## QUESTIONS REPORT

for HLT-29 rebuttal Questions

## Question #20 flow path to prove the FE1 and 2 alarm structure

# Control Bank Insertion Limits Low-Low Alarm Setpoints

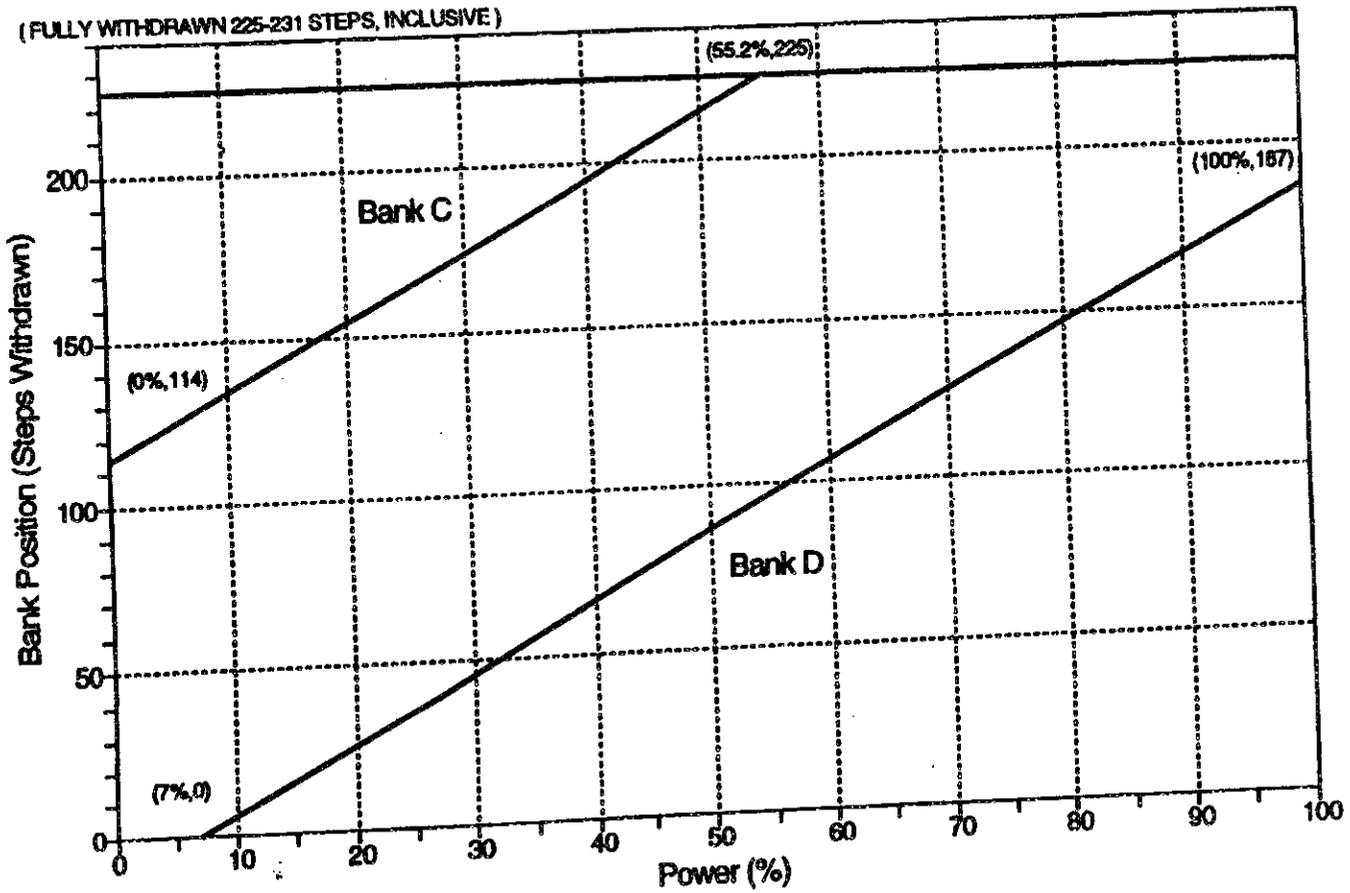
The P/A converter is shown on tech manual drawing 6064D95 or drawing number 2. This is a wiring diagram of the P/A converter that shows the resets on the left hand side of the diagram shown and marked. The interface from Bank A, B, C, D provide up/down input to the P/A converter which causes the P/A converter to pulse up/down (count) and keep track of where the rods are. The right hand side of drawing 2 at location B2, C2, and D2 show four outputs that go to drawing number 1 into location G11, G8, G6 and G4, respectively. These feed the I.o and LO-Lo alarms.

In the question the reactor is tripped from a power level. One has to assume it is above C-114 since this would be normal for at power conditions. Since no other actions have taken place and since the step counters are at the at-power condition, one as to assume the P/A converter has not been reset locally. When the reactor trips, the step counters remain in the current position, as do the BOU and the P/A converter.

*Example of a Room posted as a Radiation area with a High rad area in it*

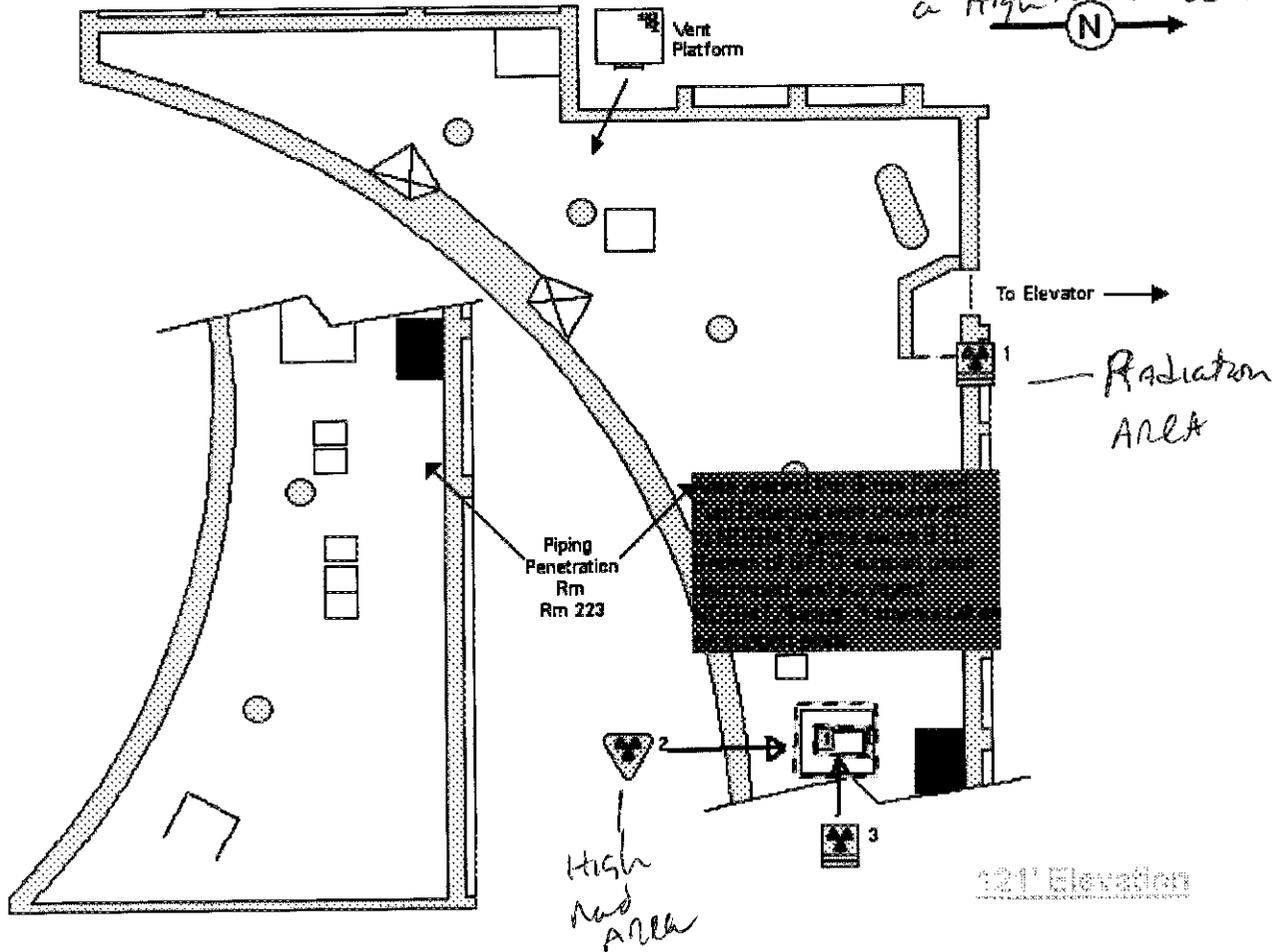
Practical experience as a System Operator where high radiation areas in larger rooms are posted closer to actual boundaries based on the radiation fields rather than the door to the room led one particular candidate to choose response "A" after ascertaining the dose at the entrance 4' away was <100 mrem an hour. This is consistent with the posting practices of the FNP Health Physics department. The facts are that the high rad area would be posted at approx. 1.5 feet from the source, and at the entrance the reading would be 12.5 mr/hr. This would not constitute a high rad area posting for the entire room.

This question asks for the posting of a certain valve room. Most valve rooms are very small in nature but at FNP, there are several extremely large valve rooms that may have more than one entrance. One in particular is the piping penetration room which has an extremely large number of valves and areas. In 1986, a commitment to the NRC was written that speaks of this subject. If a room is large, and in an effort to reduce the size of the boundaries of high rad areas, only the area around the high rad area would be posted. For smaller rooms or cubicles, the entire cubicle would be posted as a high rad area.

**Enclosed in the comments are two maps performed at FNP on 01/07/2005 and one from 01/18/2005 that shows this is how we do business at FNP.**

We submit based on these facts that both answers "A" and "B" are correct.
